Vale Street Reserve

Proposed Changes

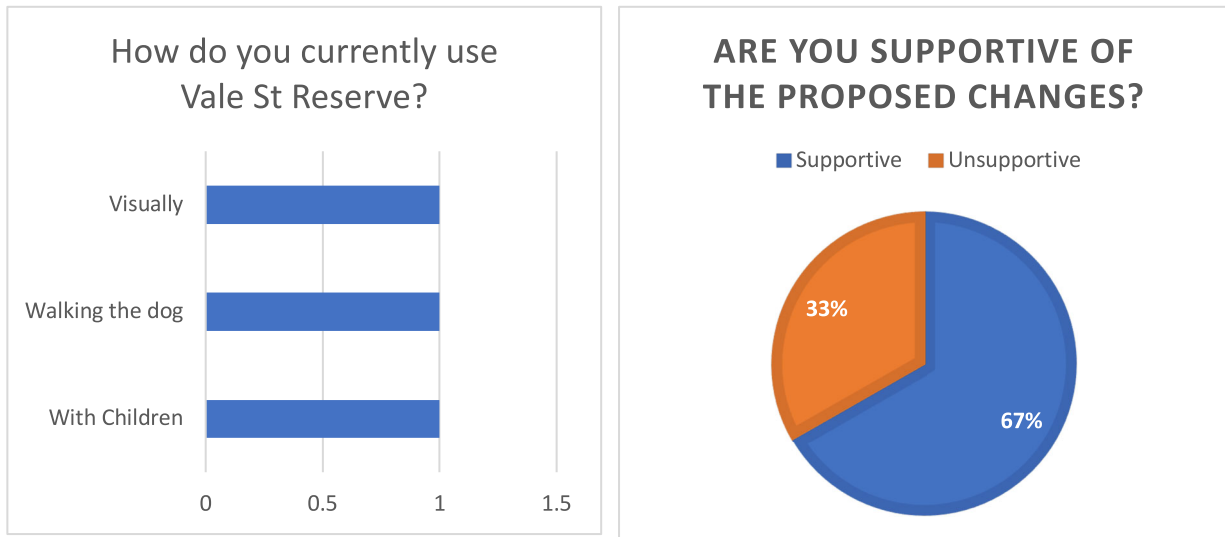
Proposed Changes Vale Street Reserve	Support	Action / Comment
Couldn't see the design	1	Please refer to MySay Ballarat where the designs are reproduced digitally and can be enlarged.
What trees will be planted?	1	Clarify in final design outcome.
Use the land for social housing with a cycling path on one side.	1	Outside of project scope/budget. Not appropriate for a local/neighbourhood park.
Many people have backyards so public play is not necessary.	1	City of Ballarat has made a commitment to providing recreation facilities within 500 m of homes.
Path connecting Arthur Street to playground is necessary.	1	This is provided in the design outcome.
Footpath (concrete) required on western side of Vale Street	1	Outside of project scope/budget. Not appropriate for a local/neighbourhood park..
Add bin	1	Outside of project scope/budget. Not appropriate for a local/neighbourhood park.
Include more nature based or formal play elements in planted out areas	1	Incorporate into final design outcome.

Additional play offerings are required.	1	This will be provided through nature play.

Ensure habitat is left for wildlife	1	Noted. Habitat provision will remain a part of the final design outcome.
Preference for indigenous trees.	1	Noted. Thank you.
Instead of native planting in splitter island, use indigenous.	1	Noted. Thank you.
Add ground cover/mid story plantings to increase biodiversity.	1	Mid story planting can obscure sight lines and must be carefully considered in small parks due to the need to retain clear lines of sight for safety and passive surveillance.

- Review the design including additional nature based play outcomes
- Include a tree planting palette of indigenous trees and low planting for habitat provision where possible.
